Intel[®] 413808 and 413812 SAS/SATA I/O Controllers in TPER Mode

Specification Update

July 2008

Figure 8. VCC1P2PLLS0, VCC1P2PLLS1 Low-Pass Filter

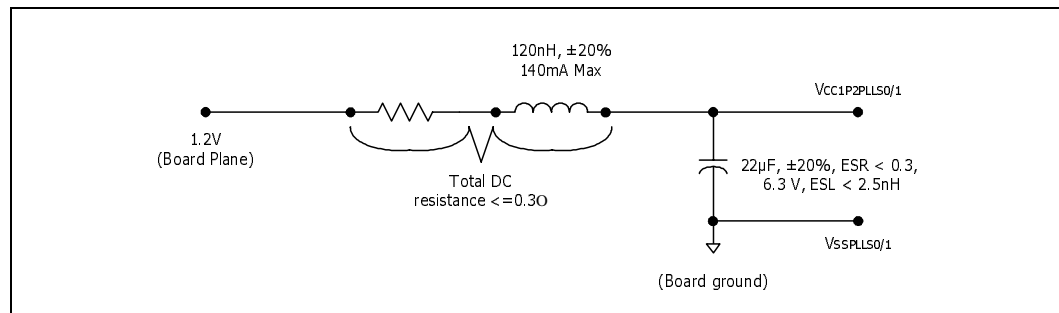
2. The VCCPLL Pin Requirements section of the Datasheet have changed

Problem: The VCCPLL Pin Requirements section of the Datasheet have changed. See below for the updates in Section 4.1 and Figure 8 in the Datasheet.

New wording for Section 4.1 - VCCPLL Pin Requirements (last two paragraphs):

This paragraph pertains to the VCC1P2PLLS0, VCC1P2PLLS1 filters. The recommended filter for the PLL supplies is shown in Figure 8. The purpose of this filter is to achieve at least 10 dB rejection of frequencies between 1 and 20 MHz. The board supply distribution system must ensure that the minimum voltage into the PLL ball is equal to or greater than 1.164 V. The current draw for the IC is 95 mA typical less than 140 mA maximum. The filter components are selected to achieve a corner frequency of 100 KHz. The series resistance keeps the Q of this resonant circuit safely below unity for all component variations. The total DC resistance of the resistor and the inductor must be equal to or less than 0.3 Ohms.

The bypass capacitor must be placed as close to the supply pins as possible. The series impedances to both the supply pin and the PCB analog ground plane must be an order of magnitude lower than the ESR and ESL specified for the capacitor. The S0/S1 PLLs have dedicated internal supplies, so the VSSPLLS0/S1 pins must be soldered directly to the analog ground plane of the PCB.

New Figure 8:
